Subject: 005-RFB-1738-2025

### Addendum One

HOOVER - B-LEVEL - SOUTH

IOWA STATE CAPITOL COMPLEX - 1305 E. WALNUT ST.

SOUTH  
 PROPOSED STORAGE PLAN

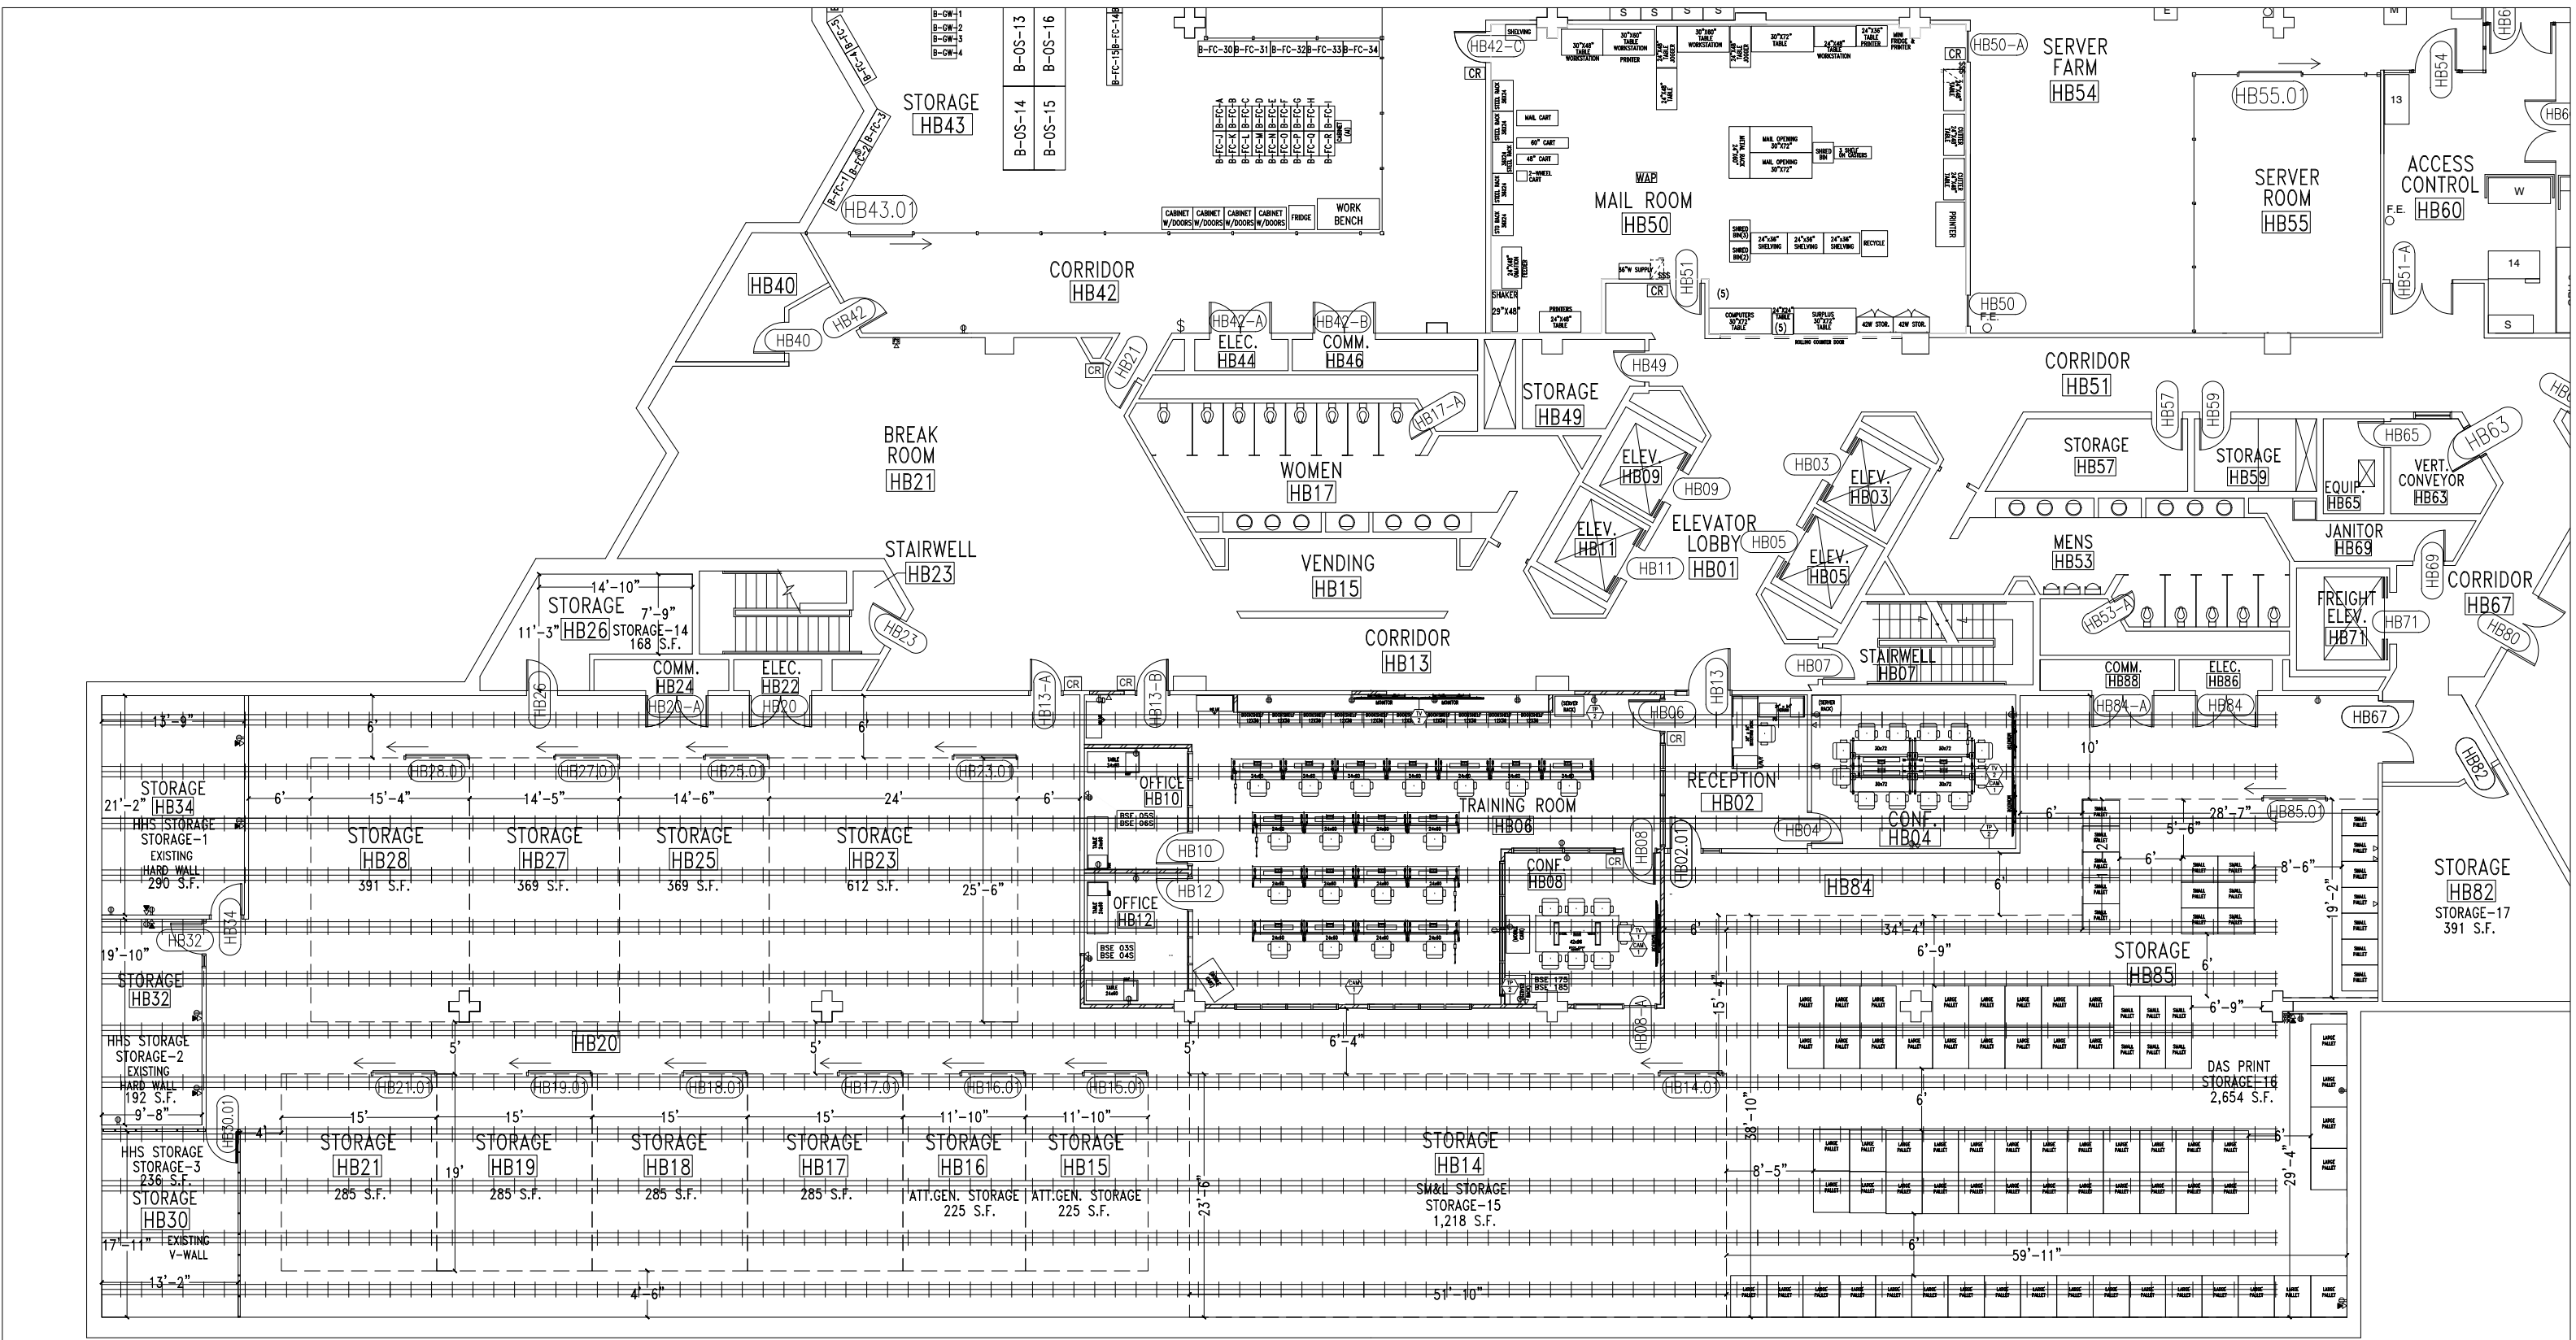
Q3) Is there any underground waterway runs, conduit, or wiring under the concrete?

Q6) Are there additional more detailed drawing details that can be provided?

A3) There is a raceway under the floor. See raceway drawing.

A6) No, other than raceway drawing.
